APPEAL SUMMARY

Appeal ID: 20746	Project Address: 12 SE 14th Ave
Hearing Date: 8/21/19	Appellant Name: Kendra Shippy
Case No.: B-002	Appellant Phone: 503-931-8915
Appeal Type: Building	Plans Examiner/Inspector: Gail Knoll
Project Type: commercial	Stories: 2 Occupancy: B Construction Type: V-B
Building/Business Name:	Fire Sprinklers: No
Appeal Involves: Alteration of an existing structure, occ Change from S to B	LUR or Permit Application No.: 19-124624-CO
Plan Submitted Option: pdf [File 1]	Proposed use: Office

14TH STREET OFFICES
12 SE 14TH AVE
PORTLAND, OREGON 97214

1 NORTH ELEVATION
A3

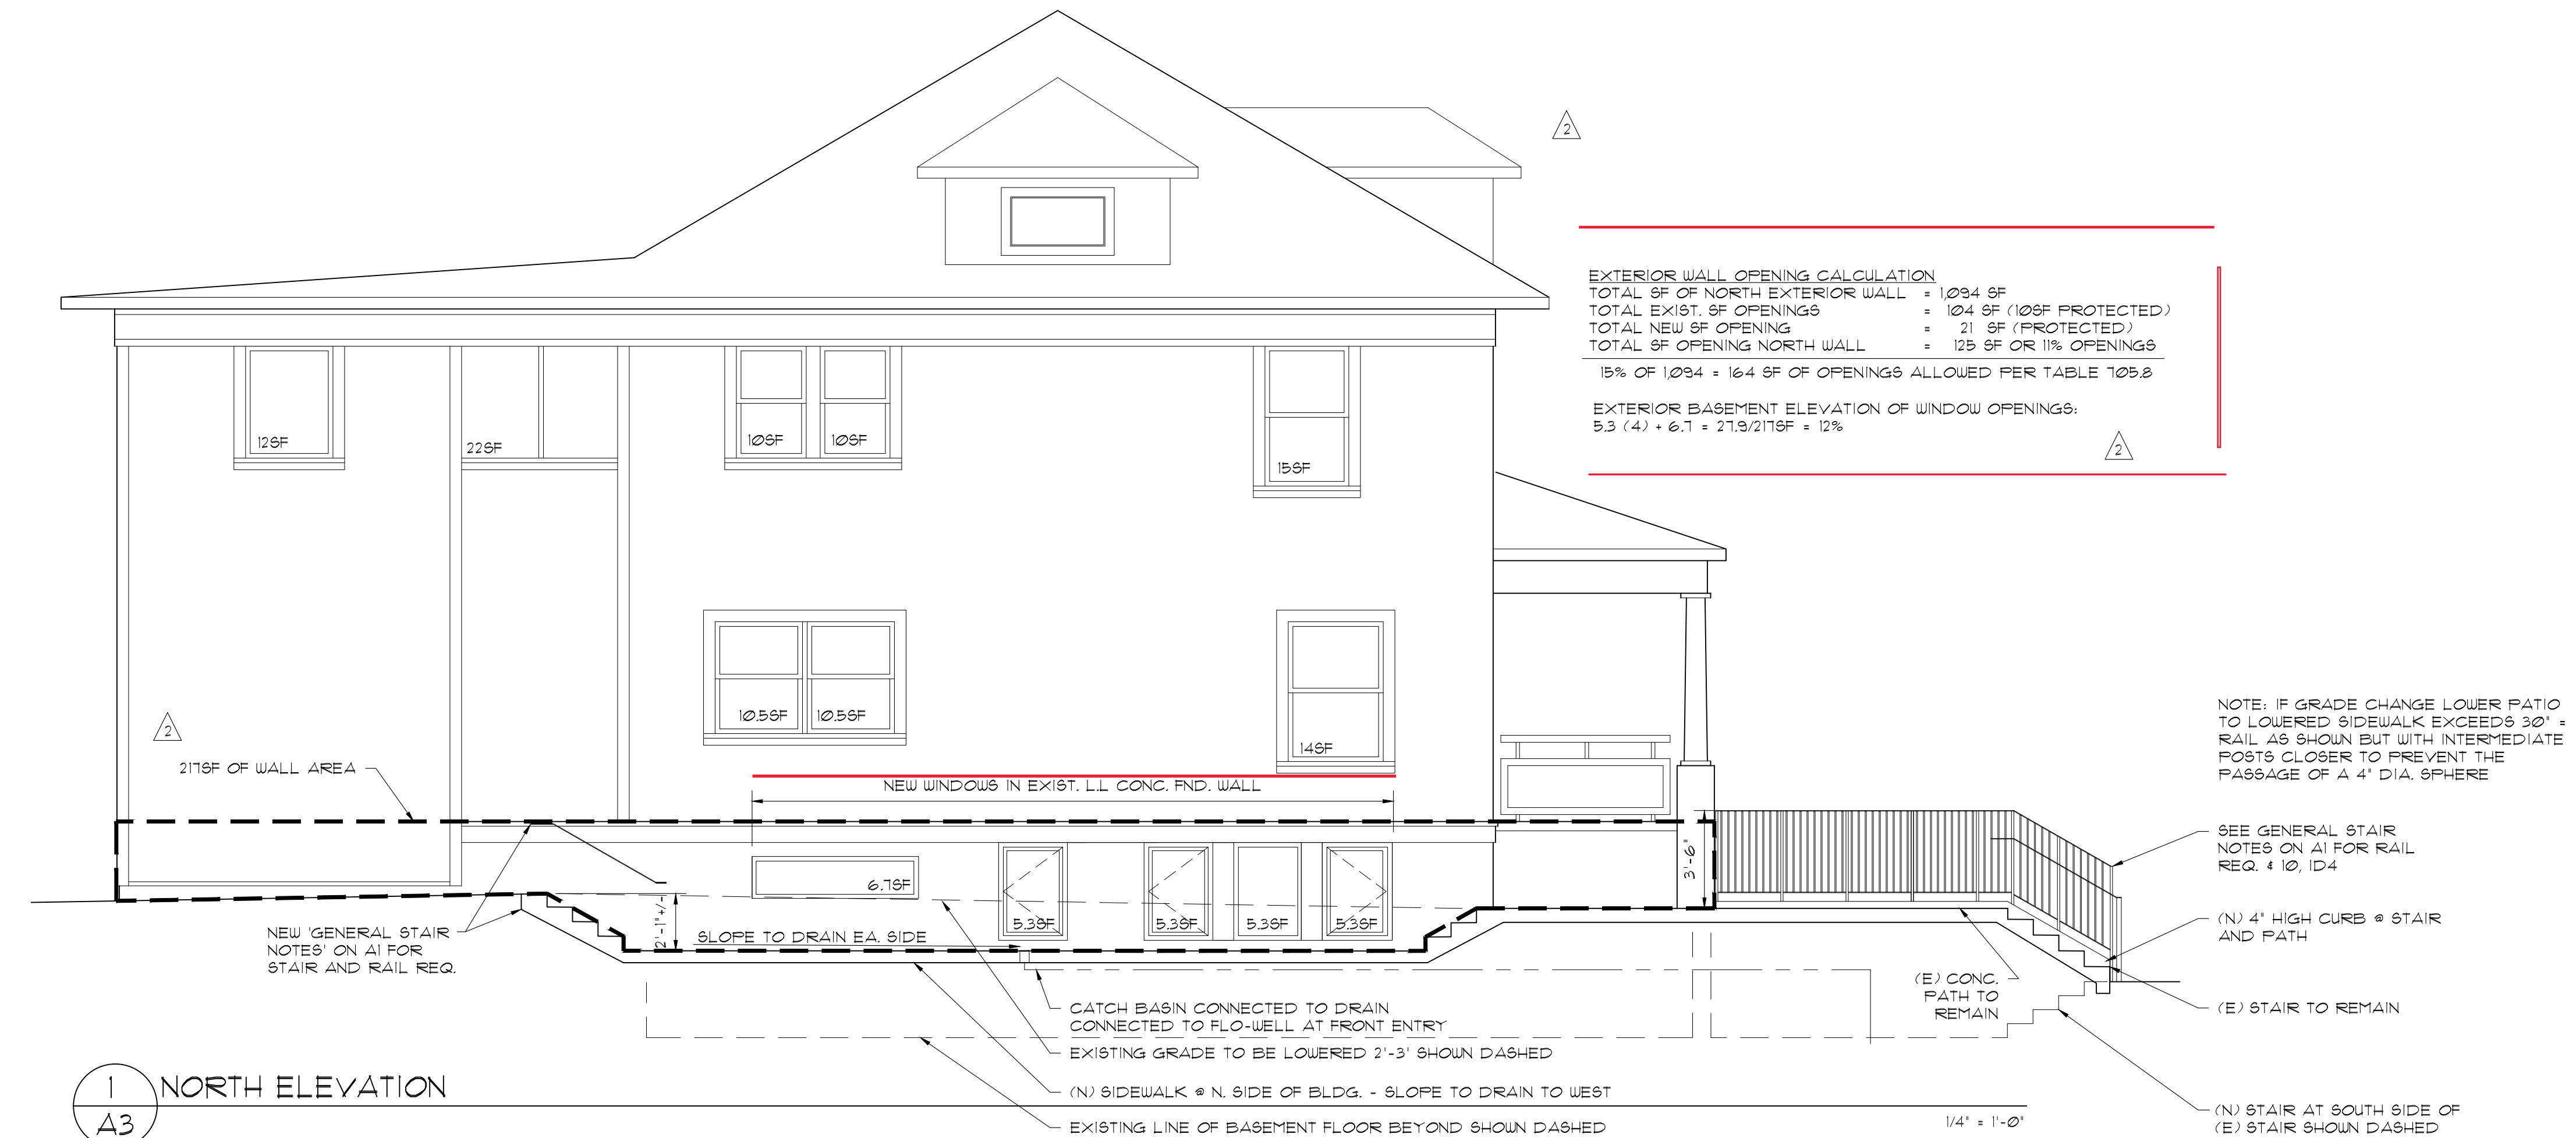
Code Section	Table 705.8, Table 716.6, Table 602
Requires	Degree of opening protection for fire separation distances of 3 to less than 5 feet shall be "unprotected, sprinklered (UP, S) with an allowable area of 15% or protected (P) with an allowable area of 15%". Exterior walls that are constructed of a 1HR fire rated assembly are required to have openings of 3/4HR fire rated assembly marked with OH-45 or W-60. Walls less than 5 feet from the property line and in a B occupancy must be constructed of at least a 1HR fire rated assembly.
Proposed Design	The design proposes new openings at the (E) 2HR concrete wall on the North facade of the basement level in a building that is not equipped with an automatic sprinkler system. The north wall at the basement level is constructed of a full height 6" thick concrete and furred with 2x4 wood studs. The basement is proposed to be a B occupancy and the wall is required to be at least a 1HR rated assembly per table 602. The total square feet of proposed openings is 127SF , or 12%, of the wall area at the North facade of the basement level. These new windows are proposed to be "protected" with a 3/4 hour rated assembly with glazing marked with either OH-45 or W-60 30 per table 716.6, Fire Window Assembly Fire Protection Ratings.

Reason for alternative	Proposal provides the required assemblies for separation distances per the OSSC 2014 code sections mentioned above. Daylight is important to the quality of the indoor environment at this lower level. The area of openings added to the North wall is less than 2% of the total North facade area. The north neighboring building at this facade has no openings and is constructed of CMU from grade to the roof. The open area between the two buildings is not used for exiting because there are no entrances into either building along these facades. It is also not a direct path of exiting.

Allowable area of openings 4 feet from property line: Hold for additional information.
Appellant may contact John Butler (503 823-7339) with questions.
